Everbrook/Learning Care Academy JSP15-57

Public hearing at the request of ICAP Development for approval of the Special Land Use Permit, Preliminary Site Plan, and Stormwater Management Plan. The subject property is located west of Beck Road and north of Eleven Mile Road in Section 17 on 4.15 acres. The applicant is proposing to construct a daycare facility in an 11,844 square foot free-standing building to serve 138 children and 22 staff members with site improvements including parking, storm water, landscape, and recreation area for kids. A daycare facility is considered a Special Land Use under PSLR overlay. A Traffic Impact Study has been submitted and reviewed by the City's Traffic Engineering consultant.

PLAN REVIEW CENTER REPORT
April 29, 2016
Planning Review
Everbrook/Learning Care Academy
JSP15-57

SITE PLAN

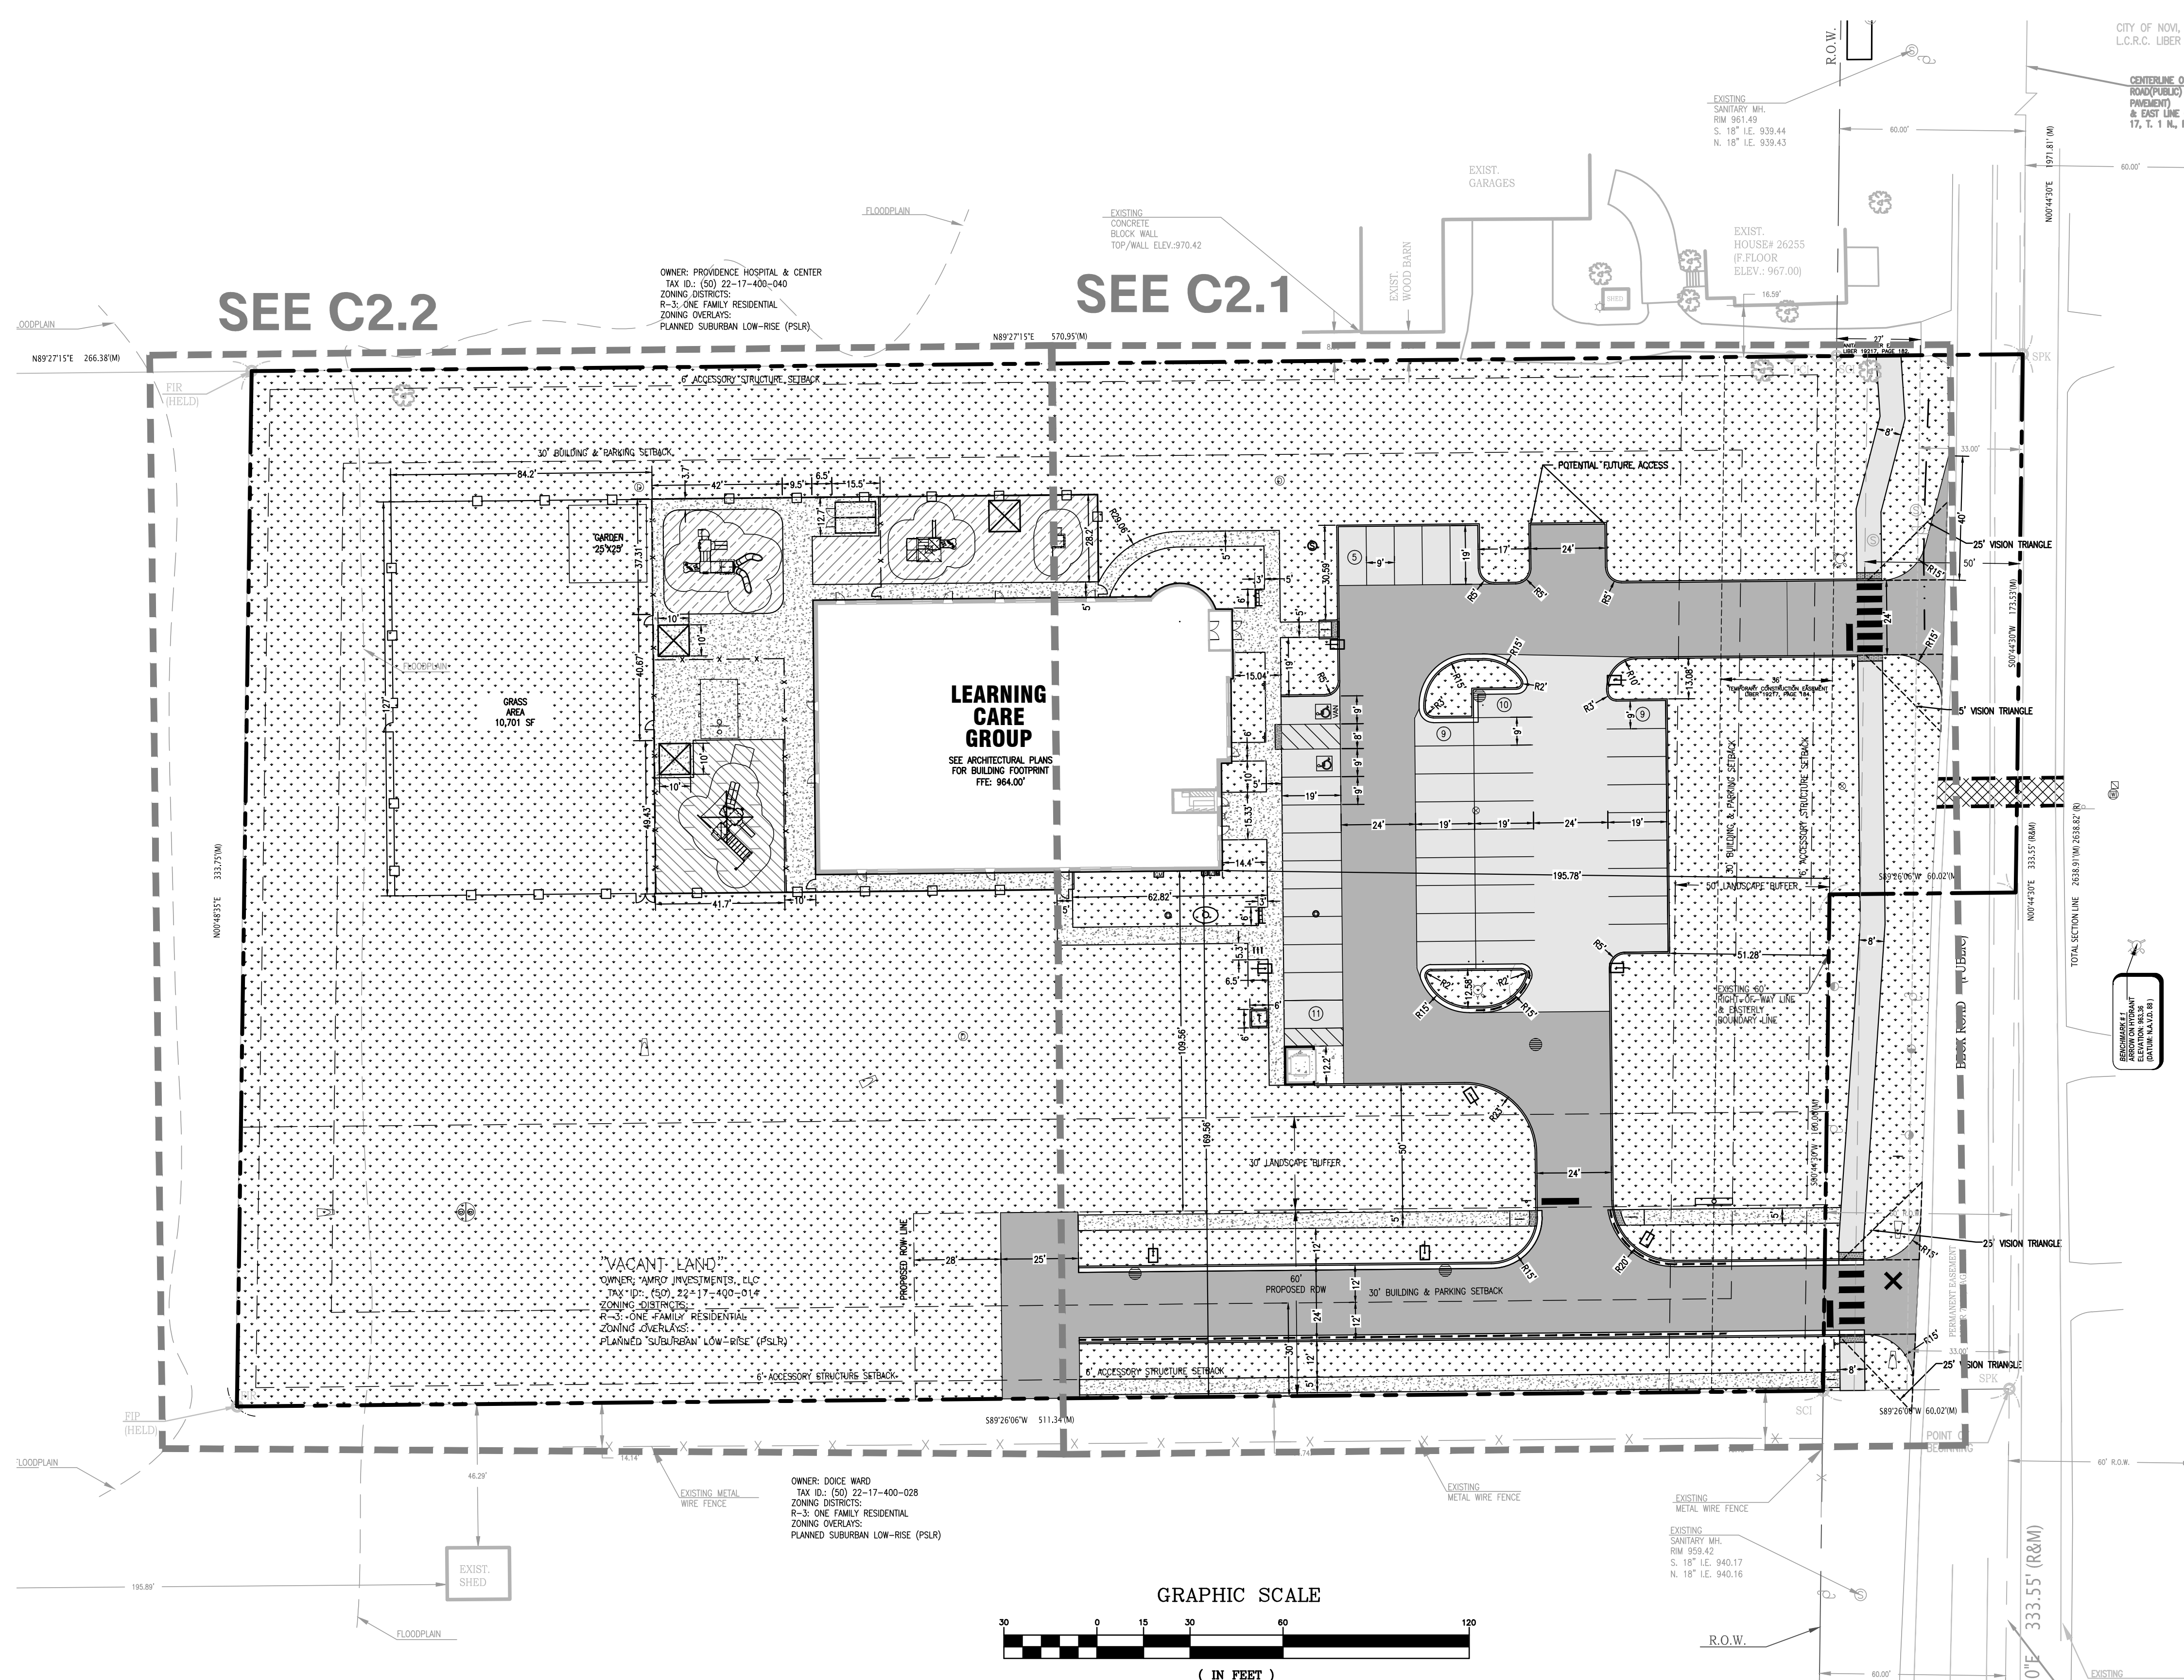
1. Building, Parking and Accessory Setbacks (Sec. 3.1.23.D): The site plan indicates the setbacks measured from the existing property line. **The setbacks are required to be measured from the proposed Rights-of-Way after dedication. Please revise the drawings to indicate the proper setbacks.**

2. Loading Spaces (Sec. 3.21.2.A.vi): Loading spaces required based on the proposed use. **The current site plan does not indicate a loading space. If the proposed use does not require a loading space, then the applicant shall provide the reasoning in the response letter.**

3. Outdoor Lighting (Sec. 3.21.2.A.x): Outdoor lighting of parking lots, access drives, and pedestrian and bicycle facilities shall meet the special conditions. **Provide light details of height and cut-off angle. Provide note if direct light source is not visible at road ROW. Adjust lighting to meet maximum illumination at property line of one-half foot-candle.**

4. Day Care Standards (Sec. 4.12.2): The hours of operation shall be limited to the period between 6 a.m. and 7 p.m. for those facilities abutting residential zoning districts. **Provide hours of operation of the day care facility on the plan sheet.**

11. Pedestrian Connectivity: Provide a sidewalk connection from in front of the building to the proposed sidewalk in the road right-of-way.
12. Legal Documents: Once Preliminary Site Plan approval is obtained, please provide the Master Deed and ROW dedication legal documents with the Final Site Plan submittal.

Figure 3. City of Novi Figure IX.10, Standard Warrant for Right Turn Lane or Taper

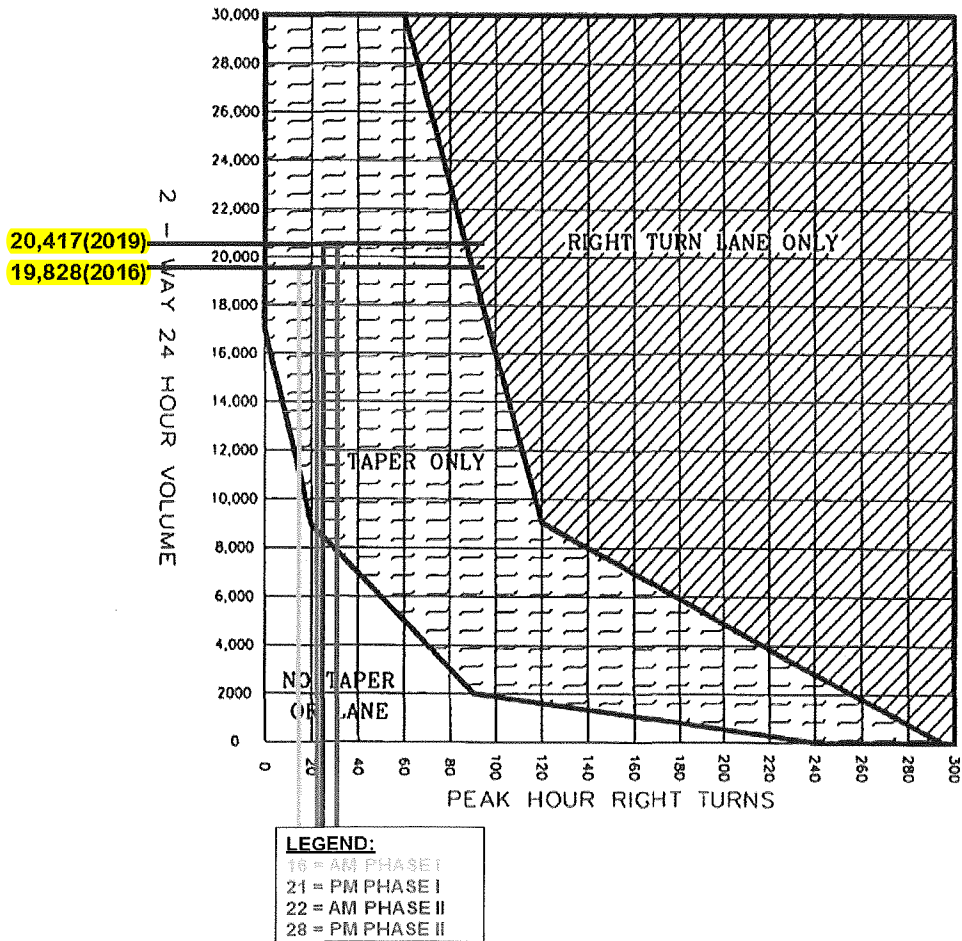
- Please indicate the sight distances at both Beck Road interfaces.
- Based on anticipated volumes presented in the Traffic Impact Study (TIS), a southbound right turn taper is warranted. The taper is only designed to be 40’, while the City Ordinance generally recommends a standard length of 100’, with an acceptable range of 75’ to 100’. It is recommended that the applicant increase the length of the taper to a minimum of 75’ since a 100’ taper does not appear to be feasible due to the location of the northern property border. The purpose of the increased taper length is to provide enough distance for right-turning vehicles to decelerate to an appropriate turning speed while reducing the impact on southbound through traffic.

JOB NO. 20150884	HUBBELL, ROTH & CLARK, INC. CONSULTING ENGINEERS	SHEET NO.
DATE DEC 2015		AM TRAFFIC VOLUMES - PHASE II (2019)
		OF 4

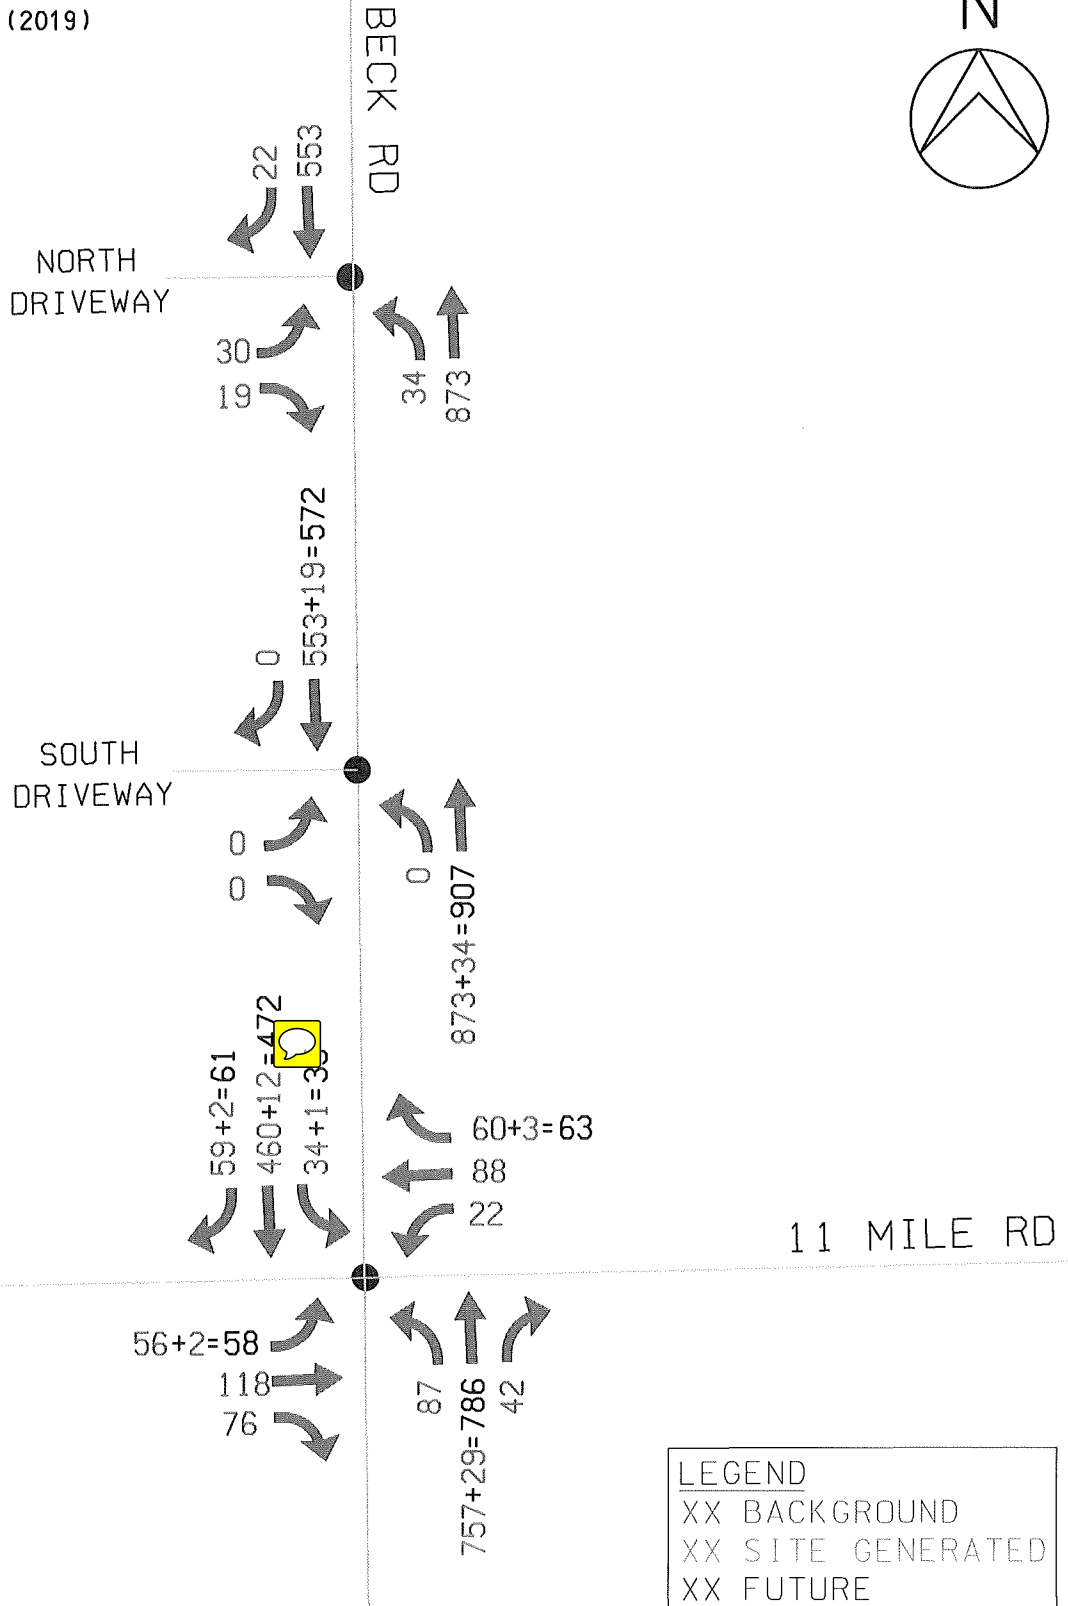
6. The Beck Road southbound thru “site generated” volume at 11 Mile Road shown on Sheet 3 of Appendix E should be changed from 12 to 16 to display accurate distribution of the total site-generated traffic. The correct value of 19 was used in the Synchro models and there is not a need to reevaluate the impacts.
